**SP AusNet Revenue Determination:
Technical Review**

**Findings on SP AusNet's
Revenue Proposal**

**Report to
Australian Energy Regulator**

**Energy Market Consulting associates
Strata Energy Consulting**

Figure 5: Capex comparison with 2007-08 RP and associated AER Decision

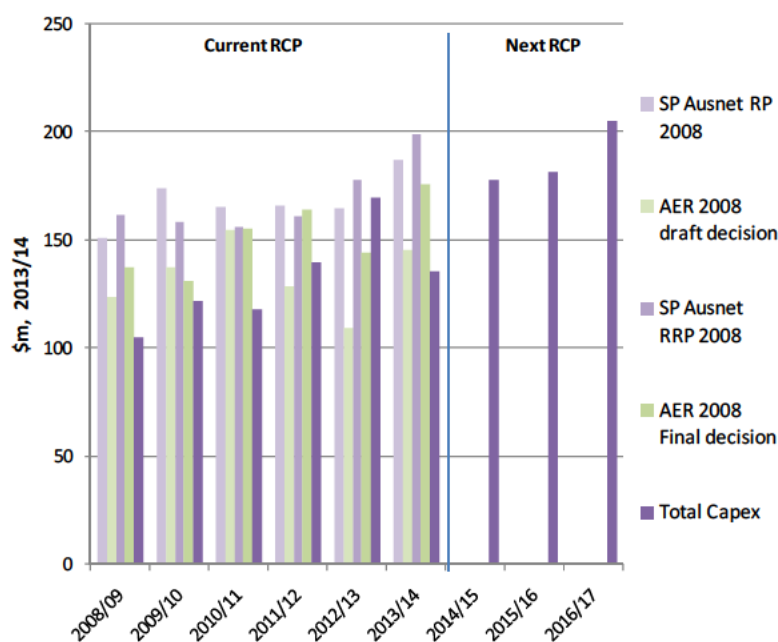
61. Figure 5 compares current RCP actual/estimated capex with the current RCP determination figures: SP AusNet’s initial RP, AER’s Draft Decision, SP AusNet’s Revised Revenue Proposal, and AER’s Final Decision. Figure 6 tracks cumulative proposed / actual expenditure. It can be seen that in aggregate, and in all years except 2012/13, SP AusNet’s actual capex was less than was allowed for in the AER’s Final Decision and in all years it was less than SP AusNet had proposed to the AER.

62. As shown in Figure 5, aggregate capex expenditure in the current RCP is approximately \$118m (13%) less than the AER’s Final Decision and \$224m (22%) less than SP AusNet proposed.

Figure 15: Current RCP cost estimation variance by project size

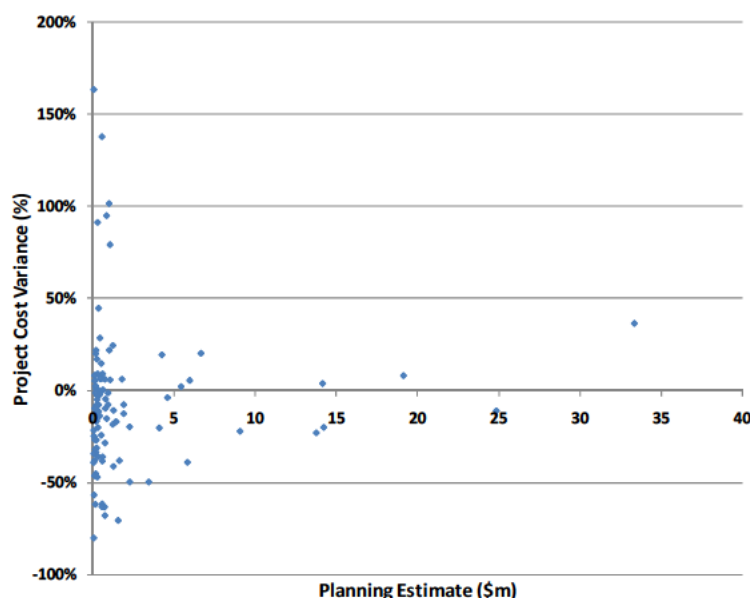
121. SP AusNet described a project close-out process (including a feedback loop on cost estimation), which is consistent with good practice. The evidence of the results from the post-project analysis was provided as requested and indicated an overall cost under-estimation of 1.4%. Figure 15 shows the variance in project cost for each project, as a function of the size of the project.

124. Overall we are relatively satisfied with the accuracy of cost estimation, where the scope is known and not subject to change as condition information becomes apparent. Although we noted some concerns with the cost estimation process, for the purpose of assessing the proposed capex we have judged cost estimation by its outcomes which we consider to be within an acceptable range, albeit biased slightly upwards. We propose applying a 1.4% cost estimation reduction to all capex, based on the estimation bias revealed from the analysis that SP AusNet provided. This cost estimation adjustment is inherent in the portfolio adjustment described in the previous section and is not additive. Therefore we ascribe 1.4% of the adjustments proposed in the previous subsection to cost estimation bias, and the remainder to portfolio-level optimisation, scope reductions and prudent deferral opportunities that will be found over the course of the next RCP.

Figure 17: As proposed(\$2013/14)

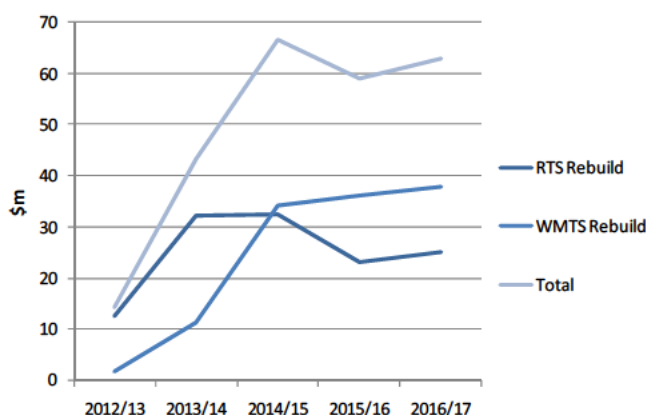
163. This is a complex project involving the replacement of nearly all of the major equipment in the three switchyards, whilst maintaining secure supplies to a major part of the Melbourne CBD. There is a fair risk of interruptions and the project will require very careful coordination and planning to avoid endangering both human lives and supply security. We note that the redevelopment of the Richmond Terminal Station is being carried out at the same time as WMTS and both of these stations supply parts of the CBD. We are concerned that the simultaneous redevelopment of WMTS will put additional pressure on the organisation and resources and increase the risk of outages and accidents.

164. The following table and graph shows the build-up of expenditure for the RTS and WMTS projects as proposed. This shows a rapid build- up to a peak of \$66.6m (\$2013/14) in 2014/15.

165. We recommend allowing for the project for revenue determination purposes, by assuming a delay for WMTS by one year to allow a slower build-up of activity to reduce pressure on resources and the associated risks. This leads to a \$26.7m shift of expenditure out of the next RCP and into the subsequent period. Table 13 and Figure 18 show the shift in expenditure that results from such deferral, which would now peak at \$61.0m, an 8% reduction on the \$66.6m peak expenditure as proposed by SP AusNet. Importantly there is a slower build-up and this peak would now occur in 2016/17, two years later than under SP AusNet’s proposed timing and would occur when the two projects are at quite different stages of completion.

Figure 33: Opex: Asset works

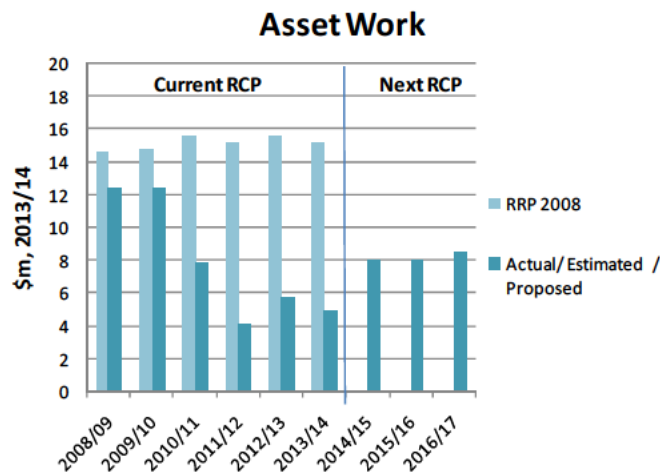
312. To assist in understanding the proposed asset works expenditure, we first reviewed expenditure in the current RCP, which is shown in Figure 33. It can be seen that SP AusNet's expenditure on asset works declined considerably after 2009/10 and, including support costs, the business spent \$45.8m, or 46%, less than it had proposed to spend in the current RCP (in \$2013/14 terms).

314. The level of variance is such as to raise questions of regulatory gaming in order to “double dip”, given that this saving has already flowed directly to SP AusNet’s bottom line and that further benefits will accrue to SP AusNet in the next RCP, under the EBSS.
